TOLLERANZE ±0,1		DISEGNATORE MARCO MAZZOLINI		DATA 18-11-2009		SCALA		PESO	
UDM	ANGOLI	CONTROLLATO							
DESCRIZIONE FLAT GASKET FOR CONNECTOR DIN43650-C				TIPO GASKET				MATERIALE	
 H.T.P. HIGH TECH PRODUCTS				CODICE		50001400A

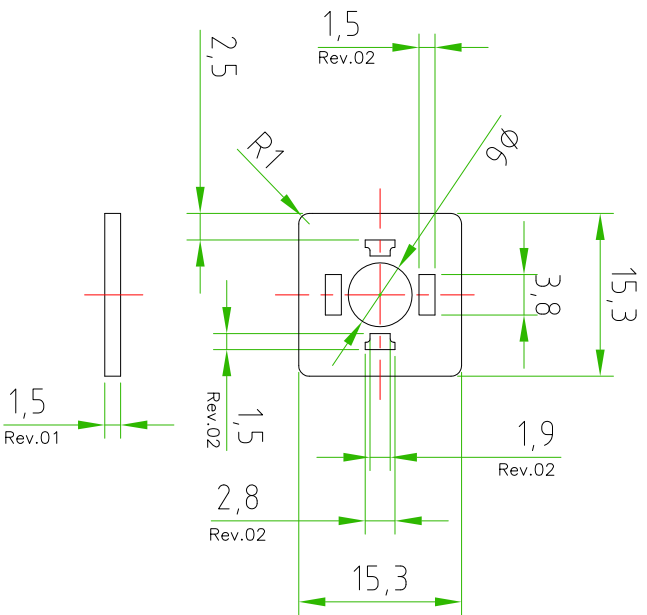
DATE	REV.	DESCRIPTION	NAME
12-03-2010	01	WE HAVE INCREASED THE THICKNESS OF THE GASKET FROM 1mm TO 1.5mm	MARCO MAZZOLINI
06-05-2010	02	WE HAVE INCREASED THE DIMENSION OF THE HOLES OF THE PINS	MARCO MAZZOLINI
